**Proposal #28: 9327-02-71**  
**T of Peshtigo CTH BB**  
**Little River Bridge & Approaches**  
**CTH BB**  
**Marinette County**

This is Addendum No. 01, which provides for the following:

**Addendum No. 01**  
**ID 9327-02-71**  
**Revised Sheet 67**  
**May 6, 2016**

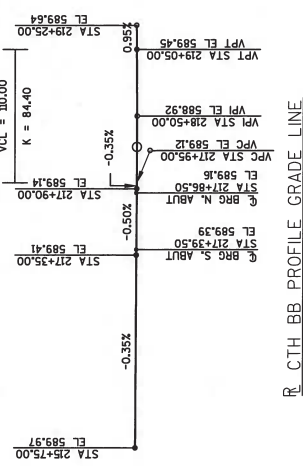
Revised Bid Item Quantities					
Bid Item	Item Description	Unit	Old Quantity	Revised Quantity	Proposal Total
503.0128	Prestressed Girder Type I 28-Inch	LF	228	60	288

Revised Plan Sheets	
Plan Sheet	Plan Sheet Title (brief description of changes to sheet)
67	Structure Plans: Revised Prestressed girder quantity in table
